Oriel Wind Farm Project Natura Impact Statement Addendum

**Natura Impact Statement - Addendum
Stage 2 Appraisal to Inform an Appropriate Assessment of Implications
on European Sites**

**MDR1520C
Natura Impact Statement
Addendum
A1 C01
December 2025**

**Figure 2A-16:
Onshore Cable Route**

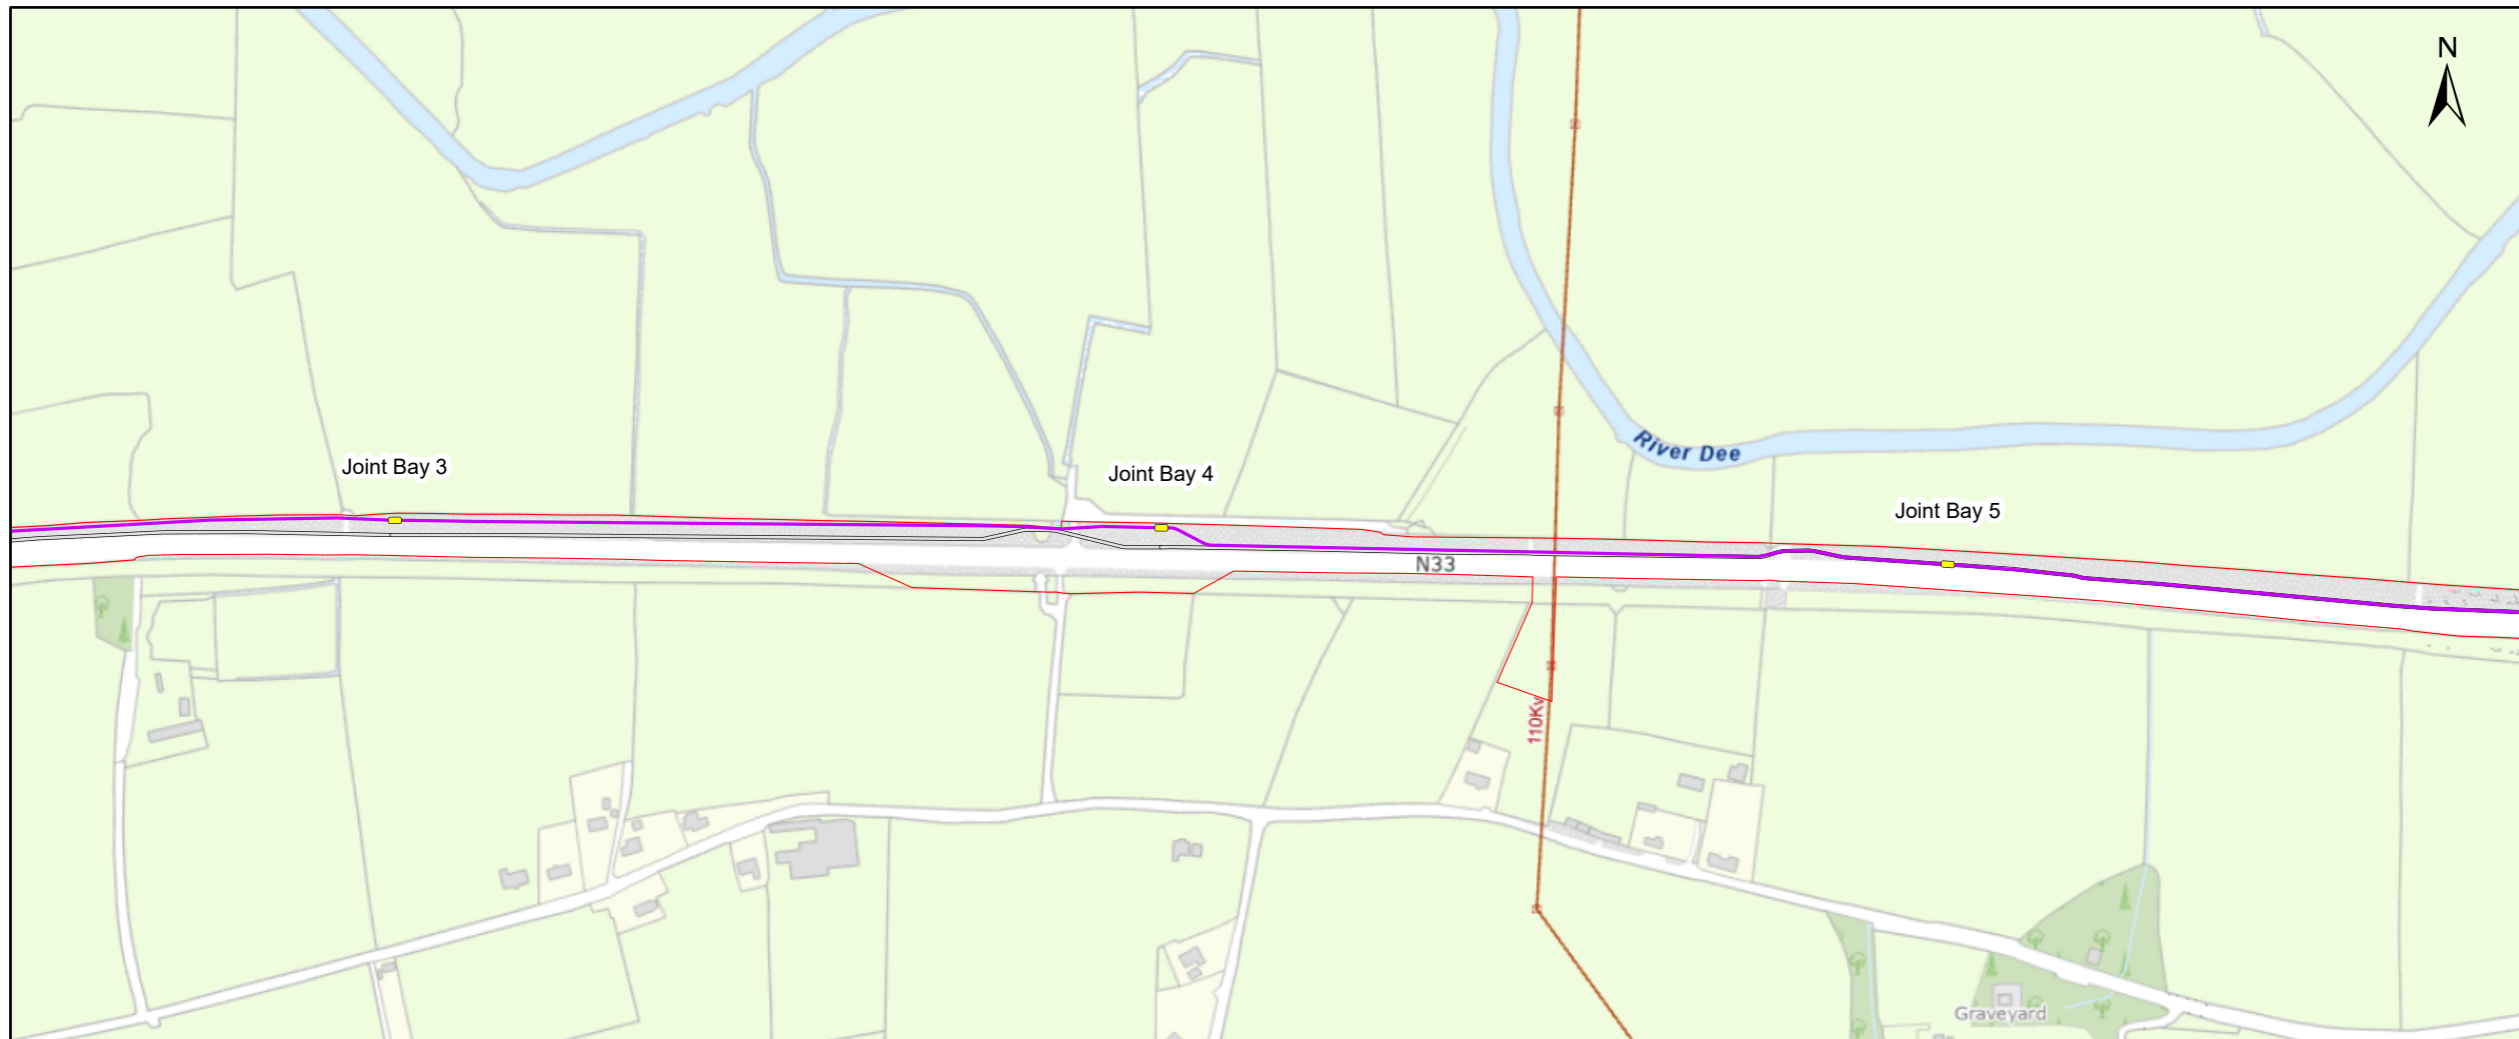
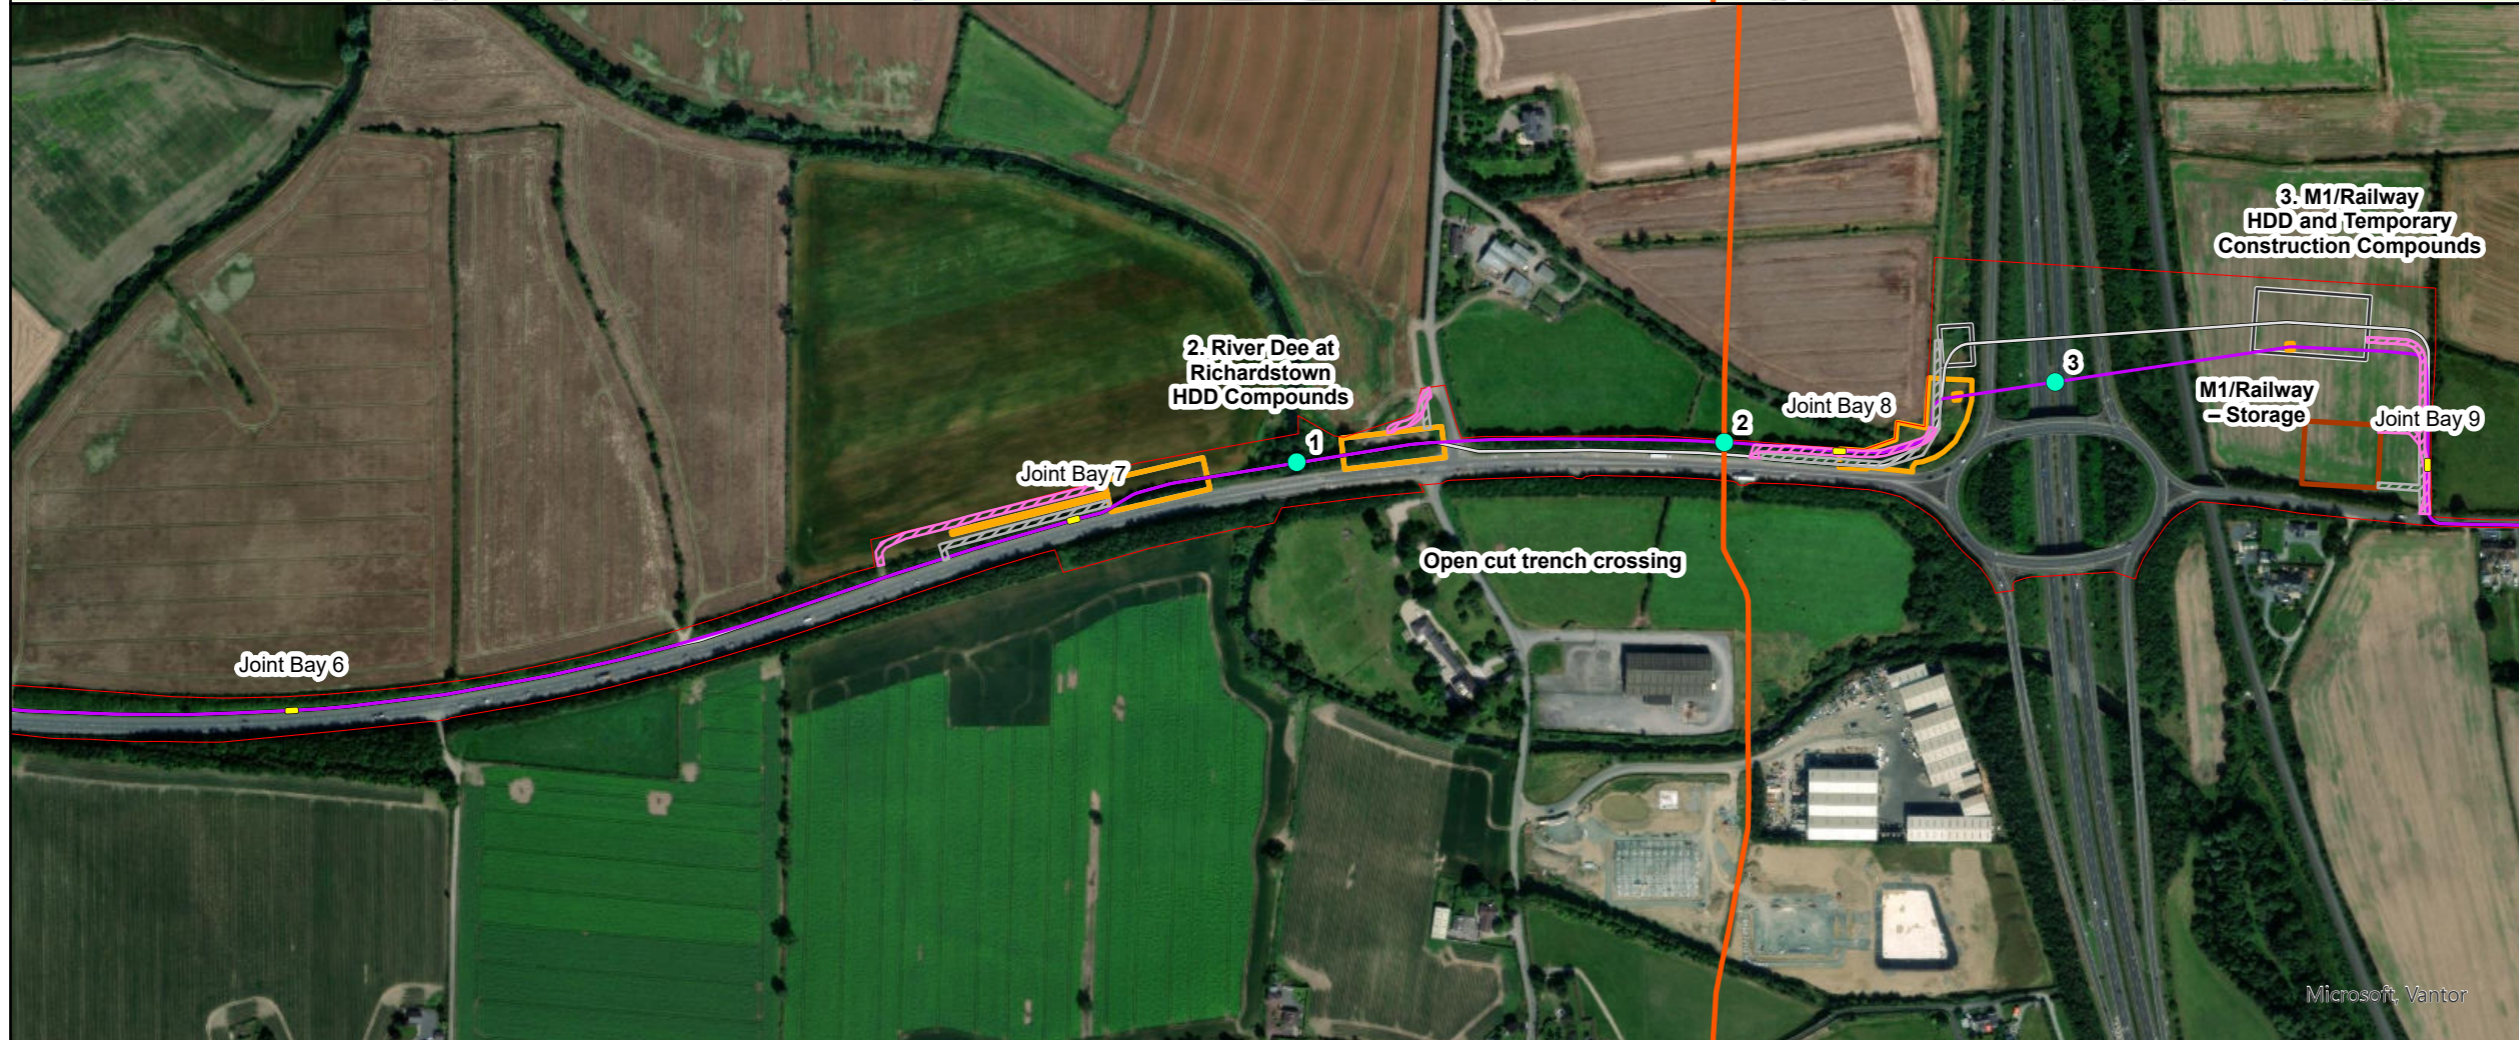
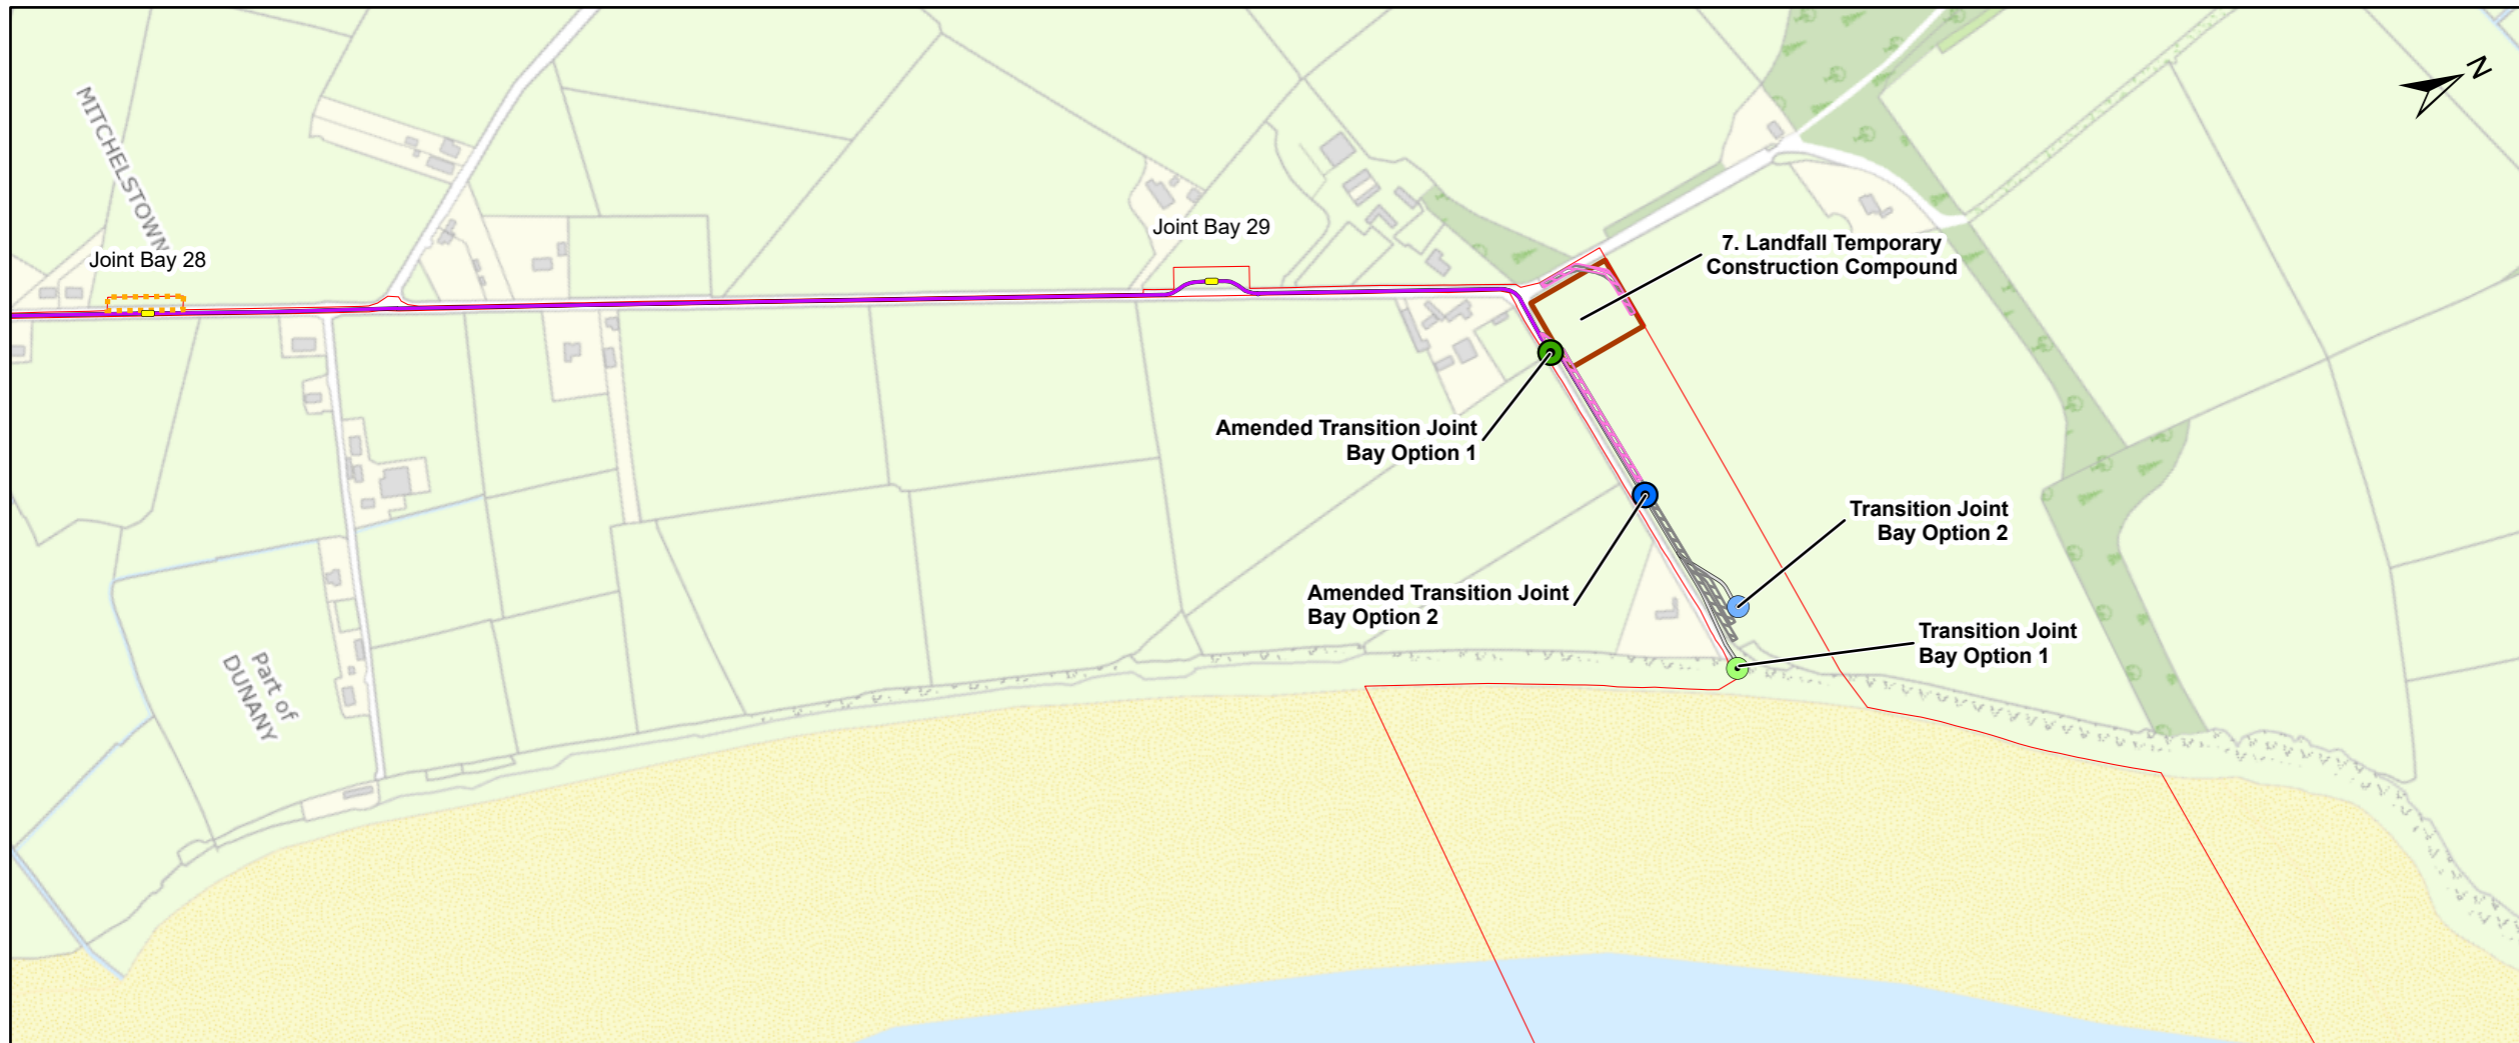
In response to concerns raised in RFI 6.K, the two options for the location of the TJB have been adjusted and are presented on Map 12 of 12 in Figure 2A-16. The two adjusted options are described below.

- **Option 1** - As shown on Figure 2A-16 (map 12 of 12) the TJB option 1 is located approximately 300 m west of Dunany beach at an existing layby at the top of the laneway leading to the beach. This option requires a realignment of the offshore export cable route along the laneway. The adjustment of the TJB location and realignment of the export cable route for option 1 is within the planning application boundary and ensures works will avoid impacts on the sedimentary cliff.

- **Option 2** - As shown on Figure 2A-16 (map 12 of 12) the TJB option 2 is located in the field adjacent to Dunany beach at the southern boundary of Dunany Demesne. The offshore cable will be installed in a trench along approximately 120 m length of the laneway, before crossing the boundary wall of Dunany Demesne into the field. An approximate 10 m section of the boundary wall will be removed to facilitate the installation of the cable, but this will be reinstated after construction. The adjustment of the TJB location and realignment of the export cable route for option 2 is within the planning application boundary and ensures works will avoid impacts on the sedimentary cliff.

In response to RFI 18.A and the submission made by TII regarding the potential impacts of the onshore infrastructure on the N33 and M1 routes, the Applicant has realigned the position of onshore cable route along the N33 (within the planning application boundary) further away from the N33 infrastructure to ensure works will have minimal impact on N33 (see Figure 2A-16, maps 1 - 3).

Figure 2A-16 (maps 1-3) show the proposed amended onshore cable route as described above along with the proposed onshore cable route which was considered in the NIS (2024).

Similarly, the access to the proposed temporary compound 2. River Dee at Richardstown, on the west has been adjusted so that an existing farm access is used (see Figure 2A-16 map 3 of 12). This adjustment was made following consultation with TII.
